Technical Note

Land South of Longfield Road, Meopham
Richborough

LAND SOUTH OF LONGFIELD ROAD RICHBOROUGH

Table 1: KCC Comments on Highway Safety

TITLE
PROPOSED SITE ACCESS WITH VISIBILITY SPLAYS

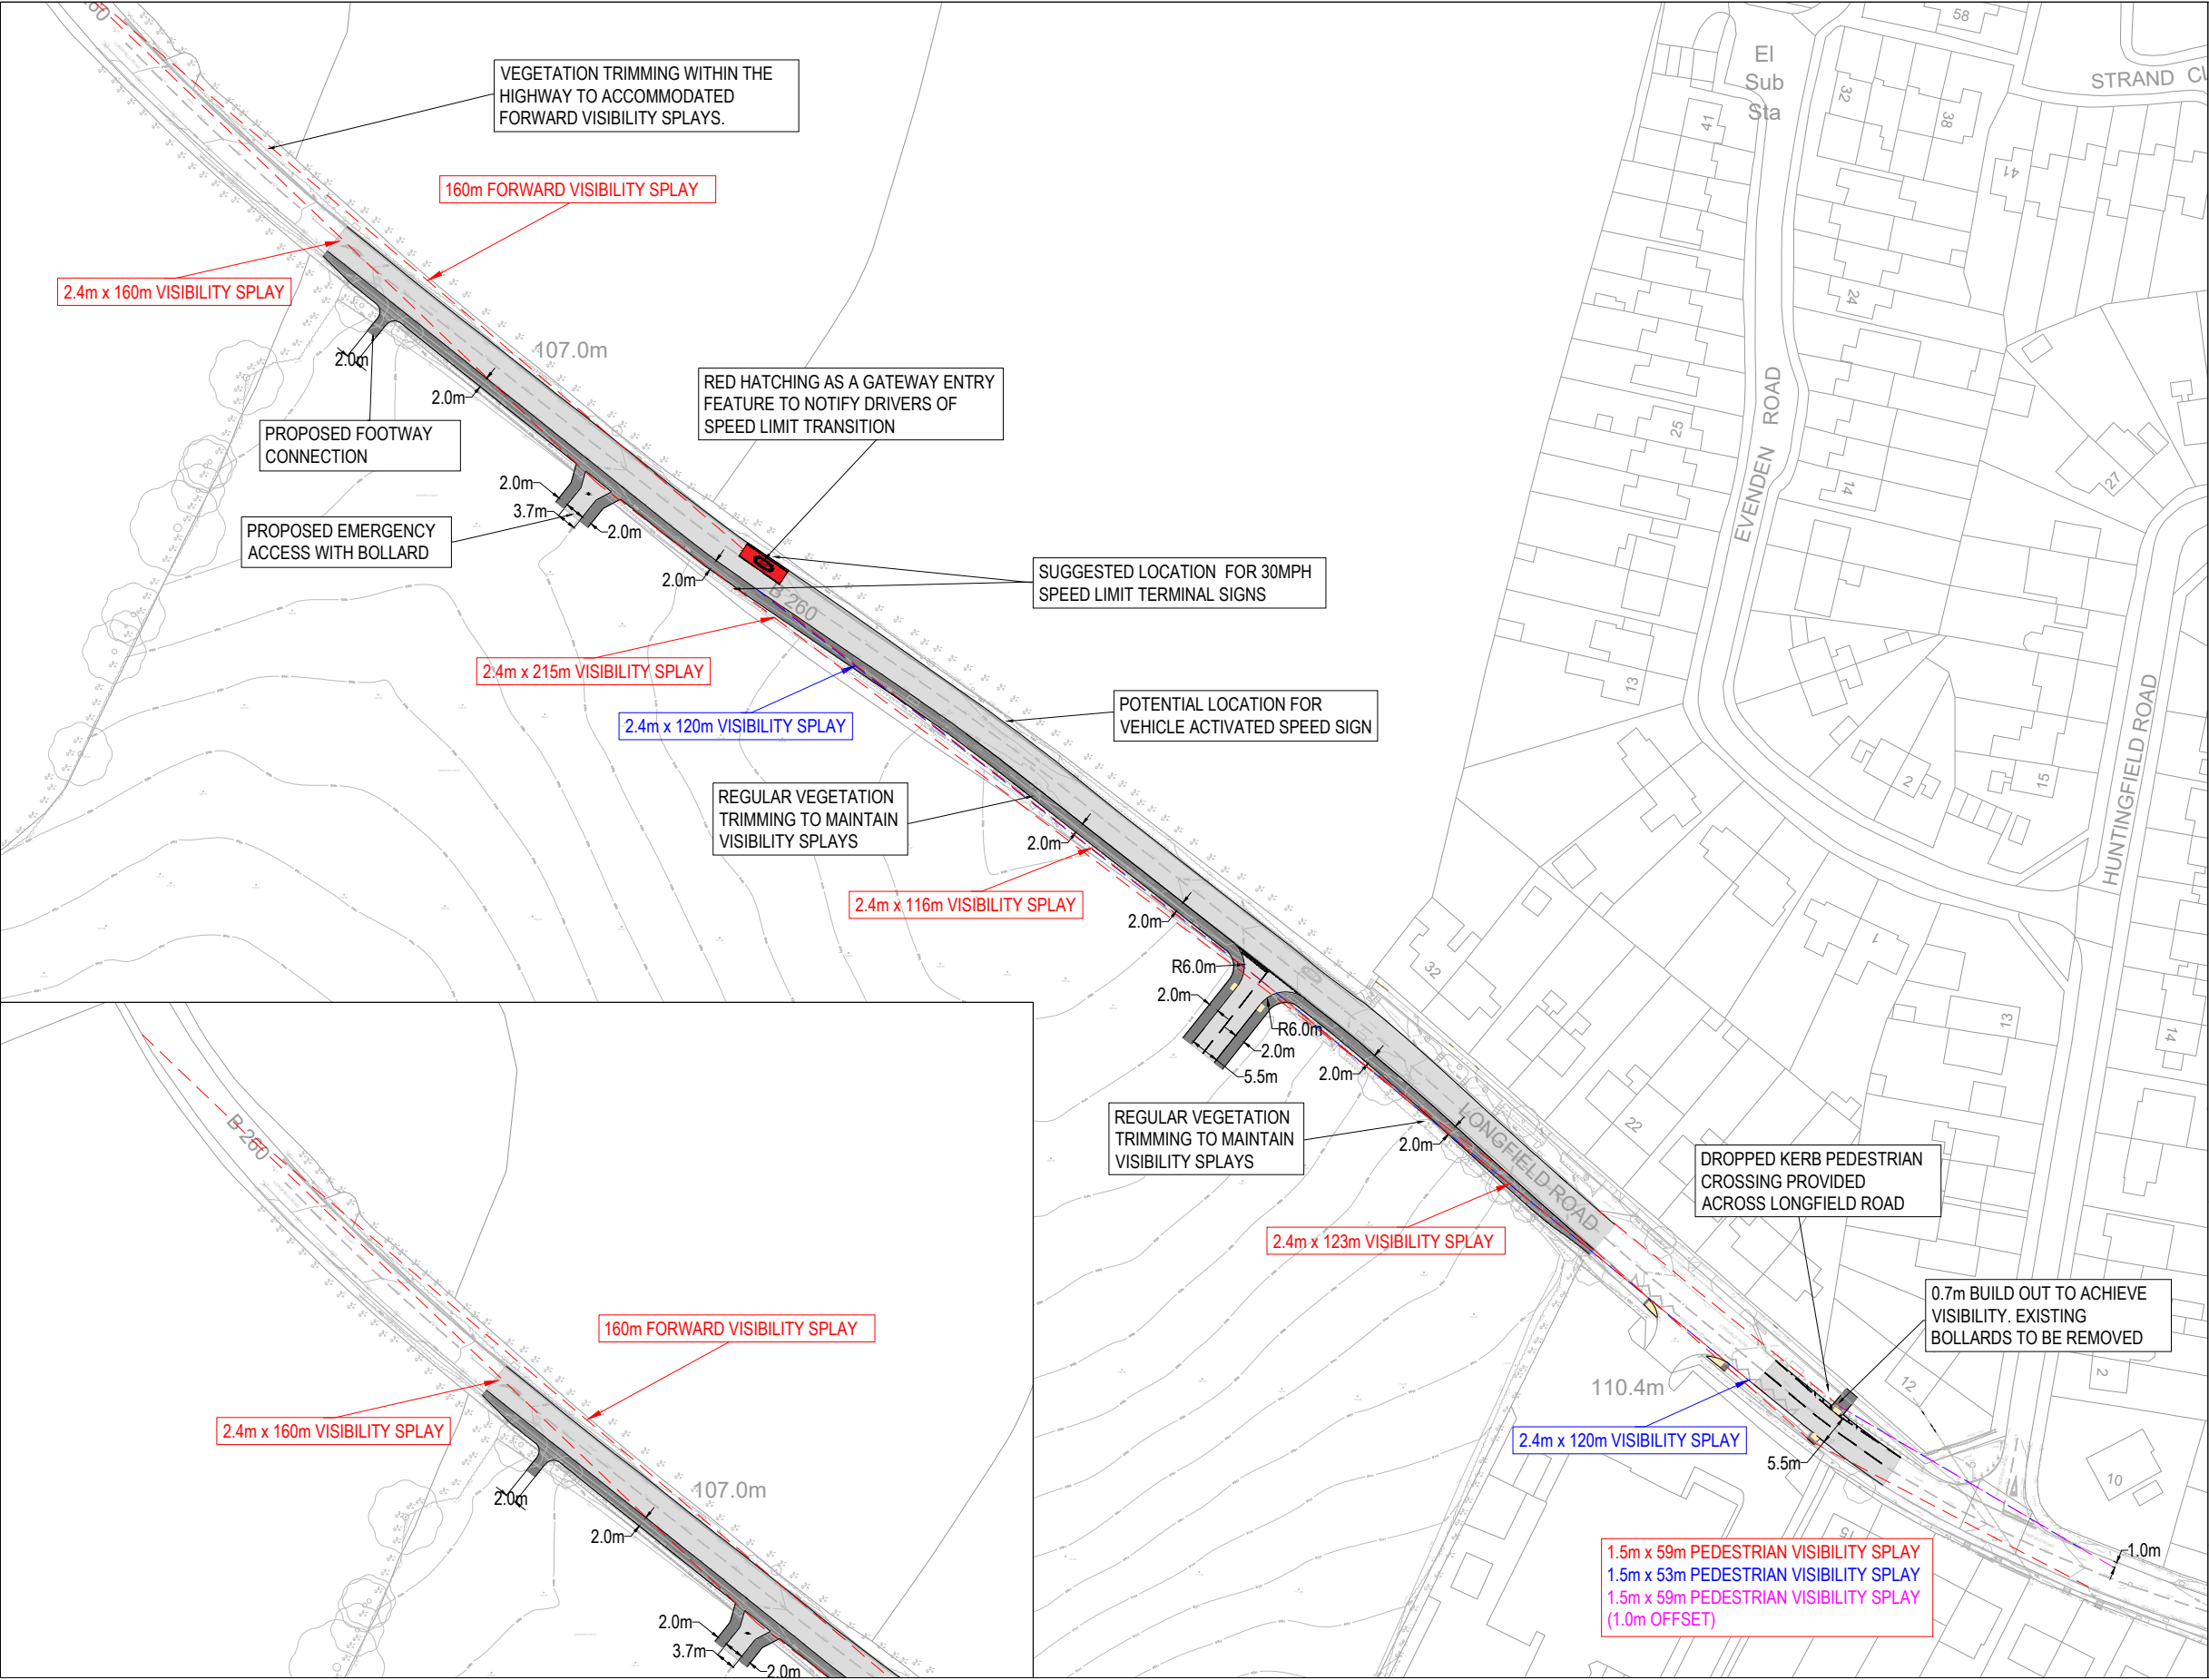
In this context, it is also noted that the red line boundary along the western site frontage does not appear to include the existing footway. Clarification is required for its omission. If no constraint exists, the applicant should extend the proposed two-metre footway along the full site frontage to provide a continuous, compliant pedestrian route linking the site access, emergency access and the additional pedestrian/cycle connection. This approach would improve permeability for non-motorised users and	Comment accepted. A 2.0m wide footway has now been shown on the plan along the site frontage, linking to all proposed access points. This is shown in Drawing T25526.001.

KCC COMMENTS	RIDGE RESPONSE
In response to observed vehicular speeds along Longfield Road being in excess of 30 mph, and in line with the recommendations from the Road Safety Auditor (Appendix H of the UTA), the applicant proposes to extend the 30 mph speed limit further west and introduce a gateway feature to indicate entry into a lower speed environment. The plan indicates that the gateway feature will include 'dragon's teeth'. However, KCC does not generally support the use of dragon's teeth on the highway. Alternative measures, such as virtual carriageway narrowing using edge of carriageway markings, red surfacing, speed roundel markings (within the 30 mph section), and appropriate terminal signage, should be considered as alternatives.	Comment accepted. The gateway entry feature has been changed to red surfacing in accordance with KCC's comment. This provides a highly noticeable feature for drivers heading eastbound. Potential locations of terminal signage have also been indicated. The amended gateway entry feature is provided in Drawing T25526.001.

KCC COMMENTS	RIDGE RESPONSE
	signposted speed limit prior to reaching the transition. As can be seen in Drawing T25526.001, the levels indicate that the transition is not at the bottom of the crest in the hill. Notwithstanding this, the terminal signage will be a minimum of 1.5m in height, which oncoming drivers will be able to see before the gateway entry feature itself. The speed transition is located c.140m west of the urban frontages, meaning drivers would have up to 300m of distance from the point at which drivers can first see the speed transition to reduce their speed prior to reaching properties and the schools to the east of the site. Considering this, the location of the speed transition is still deemed to be in the most suitable location.
Visibility splays at the emergency / pedestrian / cycle access, and the additional cycle access to the north, are also required, based on the derestricted approach speeds. Where the splays cannot be achieved, robust justification must be provided to demonstrate that any departure from standard is acceptable, or cycle access at these locations may need to be restricted, which would be contrary to the site's proposed active travel connectivity.	It is envisaged that the emergency access will only be used by emergency vehicles should the main access be inaccessible and therefore emergency vehicles would be directed to use the emergency access. This is likely to be an extremely rare occurrence and will perhaps never occur. Whilst on site, emergency services would likely clear any obstruction at the main site access and would then logically utilise this to egress the site. In the extremely rare event that emergency vehicles would need to use the emergency access to egress the site, this would be under blue light operation and therefore vehicles on the mainline would be required to slow on approach and give priority to emergency vehicles. Considering the above, we do not consider that applying the higher desirable minimum distance of 215m for a design speed of 100kph (60mph) to an emergency access is necessary in this instance. Nonetheless, we have shown that a 160m visibility splay to the west can be achieved (one step below the desirable minimum in DMRB

KCC COMMENTS	RIDGE RESPONSE
	terms) and 215m to the east, albeit it is unlikely vehicles will have reached the signposted limit at this point. This would be a relaxation as opposed to a departure from standard. The location of the proposed emergency access is considered to be in the most suitable location on crest of the hill, and also providing the shortest alternative link to the internal road network as indicated within the development framework plan. The visibility splays are shown on Drawing T25526.001 and the adopted highway extent is provided at Appendix C. As previously discussed, the link to the footway north of the emergency access is for pedestrians only and therefore visibility splays are not required here.
An uncontrolled crossing is shown to the east of the Helen Allison School. However, the visibility splays are incorrectly shown. The 'X' distance should be 1.5 m, and the 'Y' distance should extend to the nearside kerb, rather than into the carriageway. It is also noted that the crossing is located in close proximity to existing utilities, which may raise issues at detailed design.	The proposed uncontrolled crossing has been moved slightly east away from the utilities and prior to the guard railing situated outside of the pedestrian link to the Helen Alison school. The guard railing is likely present to stop children running into the carriageway and therefore we do not propose to remove this. From on-site observations, there are several vehicles observed to park on street on the southern side of Longfield Road between Huntingfield Road and Meopham Community Academy which will force westbound vehicles into the eastbound lane. Considering this, we believe this is the furthest east the crossing point could be safely located before the observed on-street parking. It should be noted that the landing point on the northern side of the carriageway is situated on the inside of the bend and by providing visibility splays to the kerb line as requested by KCC means overrunning third party land to the east. Considering this, a slight buildout (c.0.7m) into the carriageway, whilst still maintaining a 5.5m carriageway width has been proposed with a 1:20

KCC COMMENTS	RIDGE RESPONSE
	taper. This allows for a 53m visibility splay to be achieved to the kerb line to the east and 59m can still be achieved the west, both at an 'X' distance of 1.5m Notwithstanding this, we do not agree that applying visibility splays to the kerb line in this location is necessary. When vehicle visibility splays are drawn to the kerb line, this demonstrates that full visibility can be achieved of anything in the nearside lane including pedestrians entering the carriageway from the footway and overtaking vehicles. However, Pedestrians will not be looking out for other pedestrians on the footway as this is not a conflict point. Instead, they will be looking into the carriageway for vehicles navigating the parked vehicles. On that basis, a 59m visibility splay has been shown at an offset 1.0m into the carriageway to demonstrate the realistic location pedestrians will be looking (oncoming vehicle). This is considered to be more appropriate considering the surrounding constraints. Even still, the 53m visibility splays still assumes vehicles are approaching in excess of 30mph which is unlikely in this location given the presence of parked vehicles causing vehicles to slow down and navigate around them when heading westbound. Overall, the visibility splays provided at the pedestrian crossing are considered to be robust.

The forward visibility relating to the change in speed limit is incorrect and should be measured for vehicles approaching from the west, travelling towards the 30 mph zone, rather than from the east as currently shown on the plan. The required distance should be based on the DMRB stopping sight distance appropriate to a derestricted road. In accordance with this guidance, and having regard to the presence of a slight crest in the vertical alignment to the west, the applicant should update the visibility plans and demonstrate that the required sight distance is achieved with an unobstructed line of sight in both the horizontal and vertical alignment.

An uncontrolled crossing is shown to the east of the Helen Allison School. However, the visibility splays are incorrectly shown. The 'X' distance should be 1.5 m, and the 'Y' distance should extend to the nearside kerb, rather than into the carriageway. It is also noted that the crossing is located in close proximity to existing utilities, which may raise issues at detailed design.

F	UPDATED FOLLOWING COMMENTS RECEIVED FROM KCC IN FULL TA RESPONSE.	05.06.26	MJ	GM
E	UPDATED FOLLOWING COMMENTS RECEIVED FROM KCC IN INTERIM TA RESPONSE.	23.04.26	MJ	GM
D	UPDATED FOLLOWING COMMENTS RAISED WITHIN STAGE 1 RSA.	11.09.25	MJ	GM
C	ADDITION OF DMRB VISIBILITY SPLAYS	28.08.25	MJ	GM
B	JUNCTION POSITION MOVED AND VISIBILITY SPLAYS EXTENDED. CROSSING POINT MOVED TO BELLMOUTH AND ADDITION CROSSING PROVIDED OVER LONGFIELD ROAD.	17.07.25	MJ	GM
A	UPDATED WITH TOPOGRAPHICAL SURVEY	15.05.25	MJ	GM
